STAFF RECOMMENDATION
403 Scott Avenue
August 15, 2018

Application: New Construction—Infill
District: Eastwood Neighborhood Conservation Zoning Overlay
Council District: 06
Map and Parcel Number: 08302037200
Applicant: Lynn Taylor
Project Lead: Melissa Baldock, melissa.baldock@nashville.gov

Description of Project: Application is to construct duplex infill on a vacant lot.

Figure 1. Vacant lot at 403 Scott Avenue

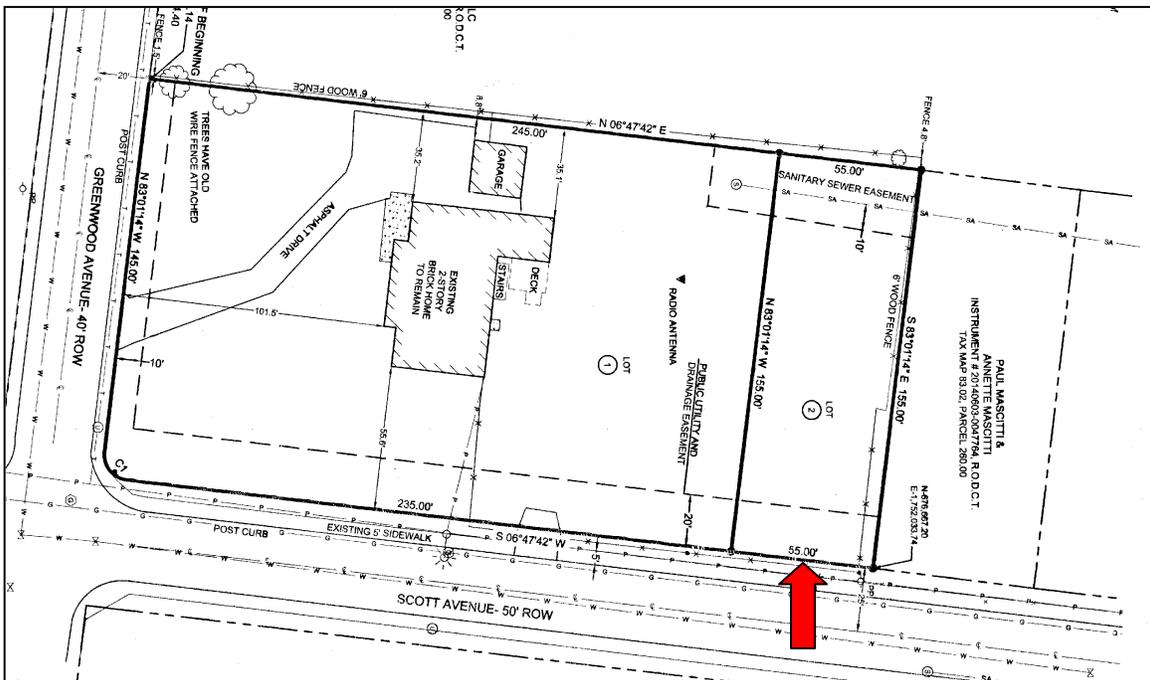
Background: 403 Scott Avenue is currently a vacant lot (Figure 1). In November 2017, this lot was created by subdividing off a rear portion of the lot at 1929 Greenwood Avenue, which is located at the corner of Scott Avenue (Figure 2). This lot marks the northern boundary of the Eastwood Neighborhood Conservation Zoning Overlay; the other houses that face this block of Scott Avenue are outside of the overlay (see Vicinity Map).

1 FRONT ELEVATION

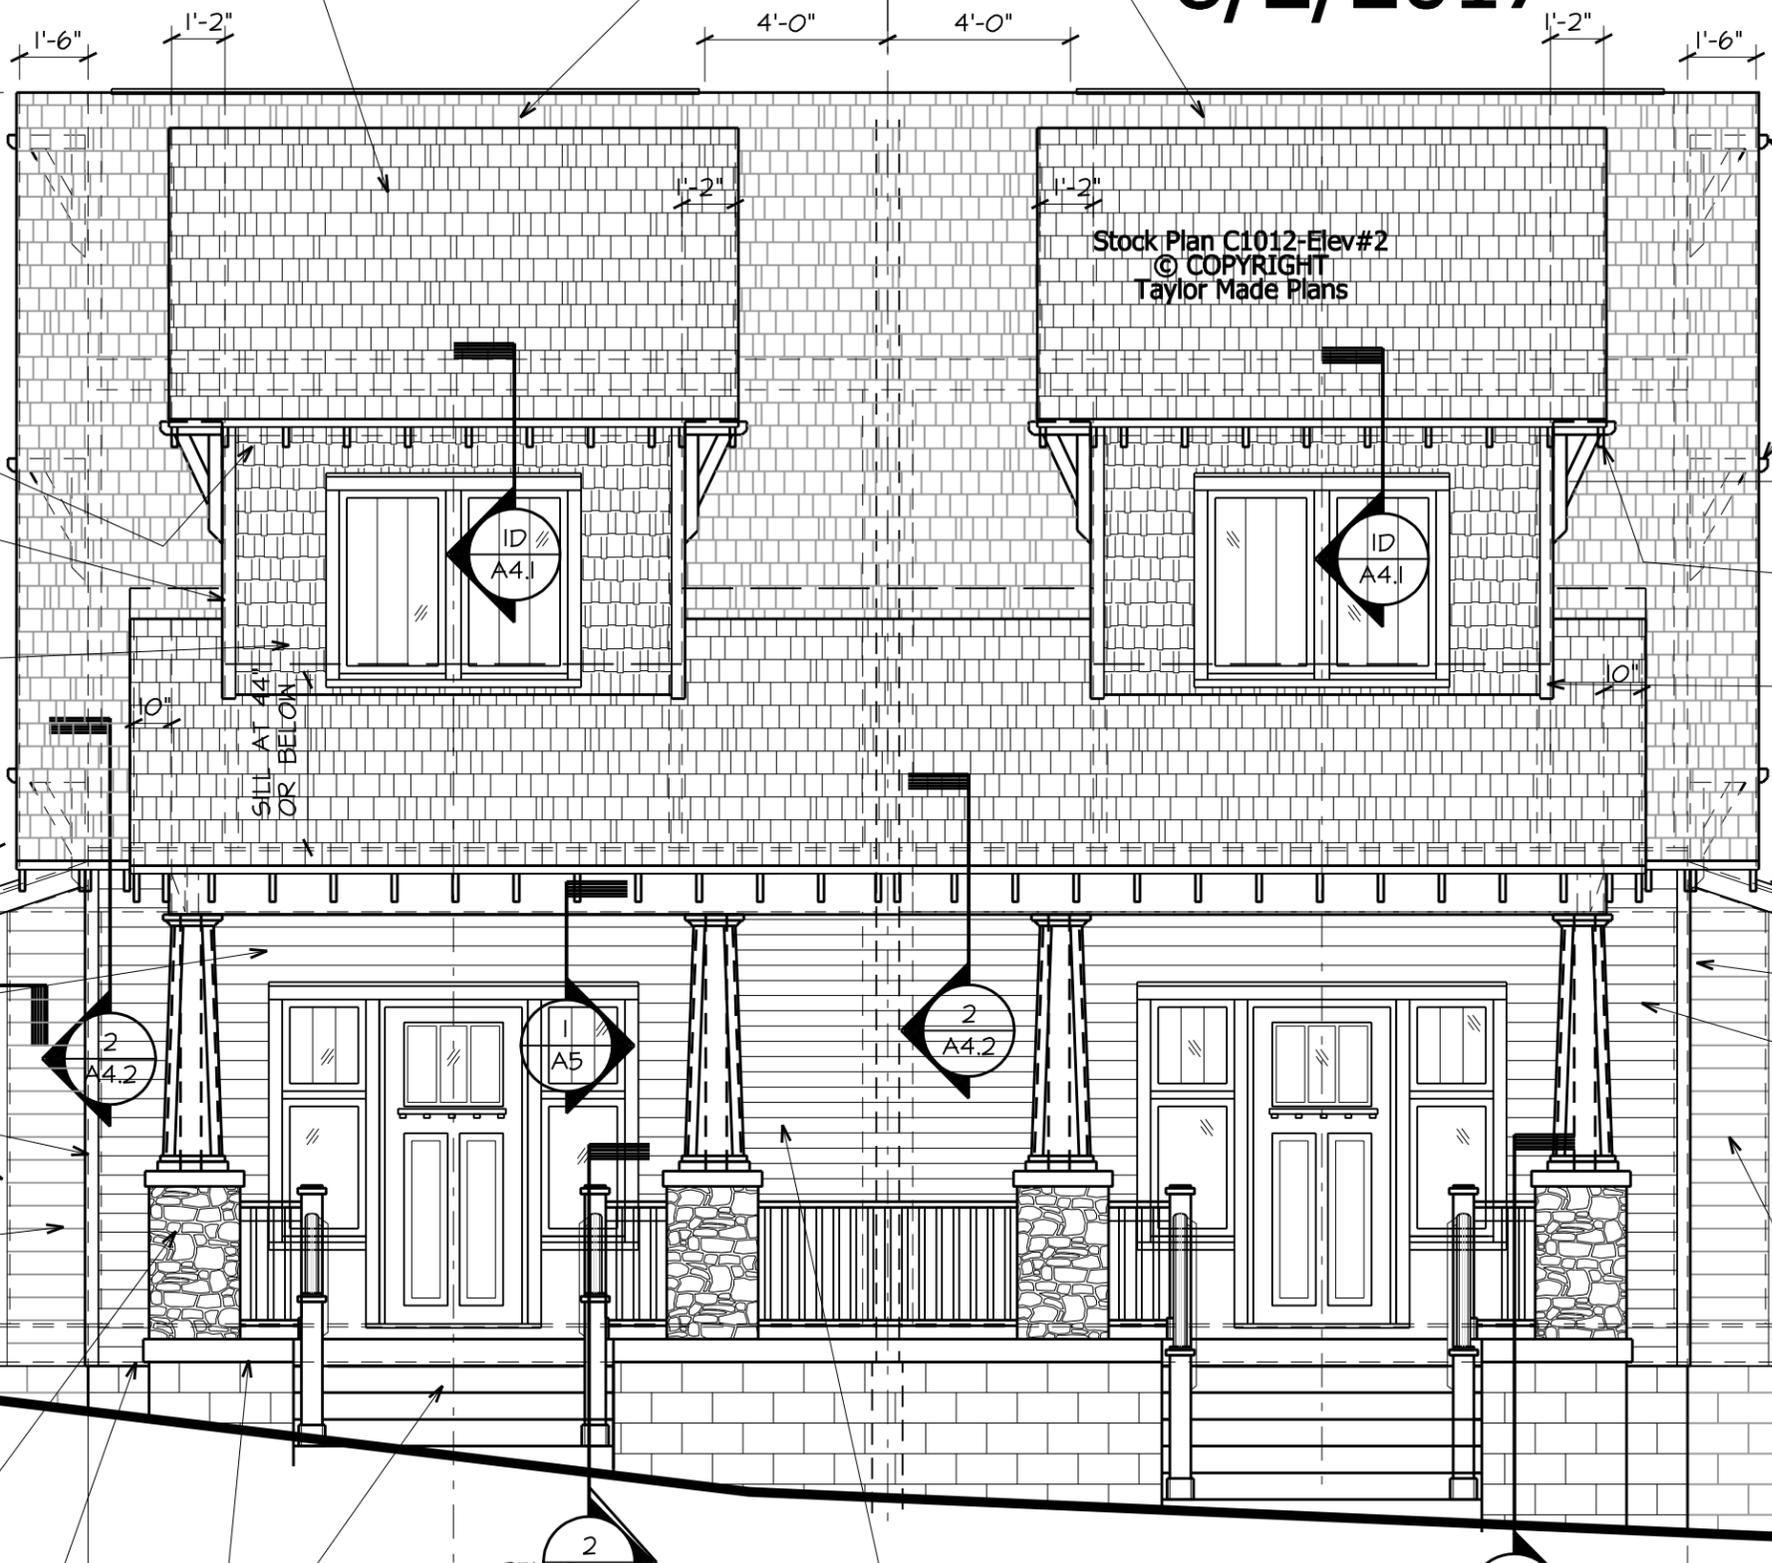
Height & Scale: The proposed infill is one-and-half-stories, with a height of approximately twenty-seven feet (27'6") from the foundation line. Because of the site's cross slope, the foundation height varies from approximately one foot to three feet (1'-3'). The eave height is approximately ten feet, six inches (10'6") from the foundation line. Staff finds the proposed height to meet the historic context, where historic houses range in height from twenty-two to thirty-one feet (22'-31'). The house will be thirty-five feet (35') wide at the front; one story bays on the side elevations extend the house to a maximum width of thirty-nine feet (39'). Staff finds this width to be appropriate, as the lot is fifty-five feet (55') wide and there are no other houses on this block of Scott that fall under the neighborhood conservation zoning overlay. The house will have a maximum depth of seventy-four feet (74'), including the front and rear porches, and a footprint of approximately two thousand, five hundred, and eighty-eight square feet (2,588 sq. ft.). Staff finds that the proposed height and scale of the infill meets the historic context and meets Sections II.B.1.a. and II.B.1.b. of the design guidelines.

Roof form: The infill's primary roof form is a side gable with a slope of 7/12. The front dormers have shed roofs and 3/12 slopes; they are inset from the wall below by two feet (2'), as is typically required. The front porch will have a 4/12 shed, and the side bays will also have shed roofs. The rear dormer is a shed with a 2.25/12 slope. Staff finds that the proposed roof forms are compatible with the roof forms of neighboring historic houses and meet Section II.B.1.e. of the design guidelines.

Orientation: The proposed infill is a duplex with two identical entrances on the front wall, facing Scott Avenue. Staff finds this to be appropriate. The infill has a full width front porch that is seven feet (7') deep. Two walkways will be added leading from the street to the two sets of front porch stairs. Vehicular access to the site will be via a new

Proportion and Rhythm of Openings: The primary windows on the proposed infill are generally twice as tall as they are wide, thereby meeting the historic proportions of openings. There are no large expanses of wall space without a window or door opening. All paired window openings have four to six inch (4'-6") mullion in between them, as is typically required. Staff finds the infill's proportion and rhythm of openings to meet Section II.B.1.g. of the design guidelines.

1. The finished floor height be consistent with the finished floor heights of the adjacent historic houses, to be verified by MHZC staff in the field;
2. The front setback be checked in the field at the staking check to ensure it is compatible with the front setback of the house next door at 405 Scott Avenue;
3. Staff approve the window and door selections, the roof shingle selection, a stone sample, and the materials of the driveway and walkways prior to purchase and installation; and
4. The HVAC be located behind the house or on either side, beyond the mid-point of the house.
